VINTAGE VIBE
ELECTRIC PIANO CO.

CUSTOMER SERVICE BULLETIN

#CSB0001

Stereo Vibe Units: Pre-Rev 5 PCBs

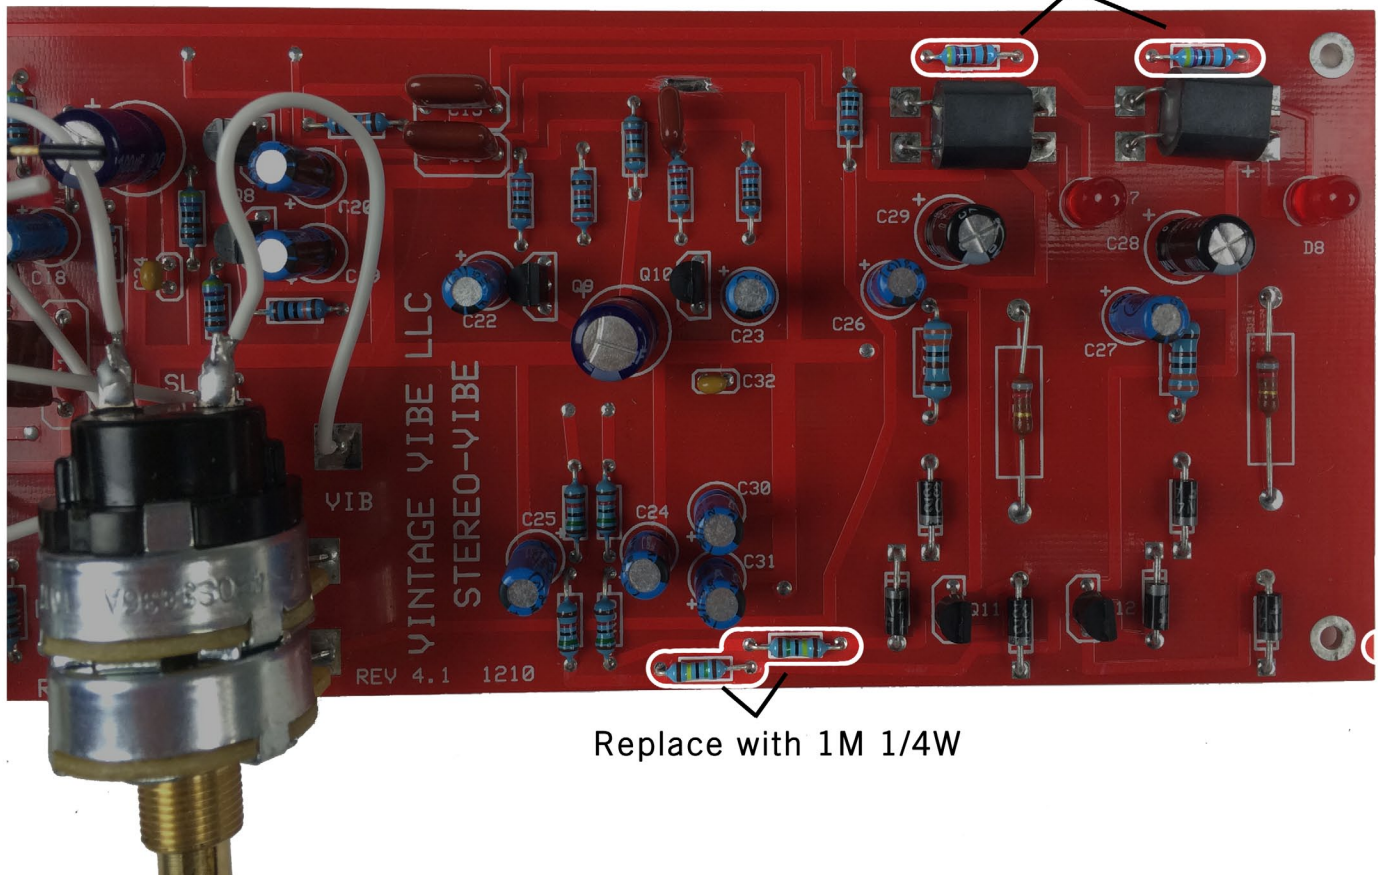
1. Mitigate the loss in output level between dry signal and that when tremolo is engaged (This is most apparent with units that have 3.9M resistors installed in R52 & R53).
2. Increase apparent effect of tremolo depth at highest speed / highest depth settings and at lowest depth setting.

Replace with 20K 1/4W

Replace with 1M 1/4W

1. Replace both R52 & R53 with 1M 1/4W Metal Film resistors.
2. Replace both R31 & R32 with 20K 1/4W Metal Film resistors.
